SAFETY RECALL NOTICE

SAFETY
CAMPAIGN

Subject: **Steering Cable Stem Arm Bolt**

No. **2007-1**

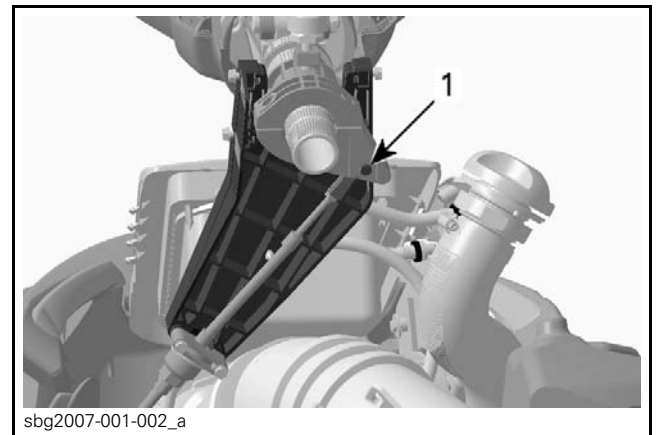
On some vehicles, the bolt securing the steering cable to the steering stem arm may be improperly installed and could allow the steering cable to disconnect from the steering stem arm. If this occurs, it may result in a sudden loss of steering and possible collision with another vessel or with a fixed or floating object. This situation can potentially cause serious injuries or even death to rider or bystanders.

- Using a flashlight, locate the steering cable stem arm bolt [1] through the storage bin opening.
- Turn the steering handle bar to help you locate the bolt and to provide a direct access.

Locate steering cable stem arm bolt and ensure it is properly installed and torqued.

-
- Using an extension if necessary, torque the steering cable stem arm bolt to 4 N•m (35 lbf•in).
When torquing ensure the bolt does not turn freely.
 - Re install storage bin and close front storage cover.
